То:	
From:	
Date:	12/11/25
Reference:	
Project name:	East of Aberline PSP
Subject:	DCP Infrastructure Costing Review

This memorandum is further to the Niche Studio Submission (20/10/25) and further reviews the East of Aberline Development Contributions Plan (DCP), focusing exclusively on proposed transport and drainage infrastructure. Our analysis identifies several items that warrant reconsideration due to limited strategic value, excessive cost, or misalignment with local context and precedent.

Figure 1: Alternative Bridge Cross Section

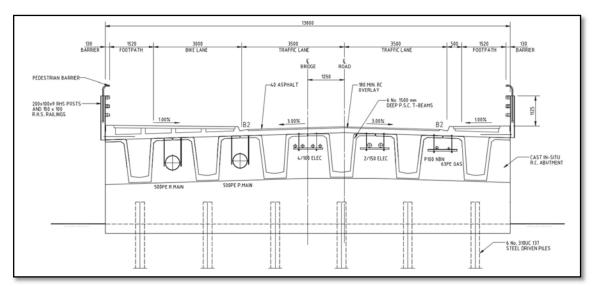
Below is an example of a recently completed bridge that provides similar functionality to that required for the BR-01 crossing.

We acknowledge that this bridge example does not directly correlate with the structure required for the Subject Site, and that additional considerations such as CHMP requirements and vegetation impacts may apply. However, we request that further work be undertaken to determine whether a more efficient option exists.
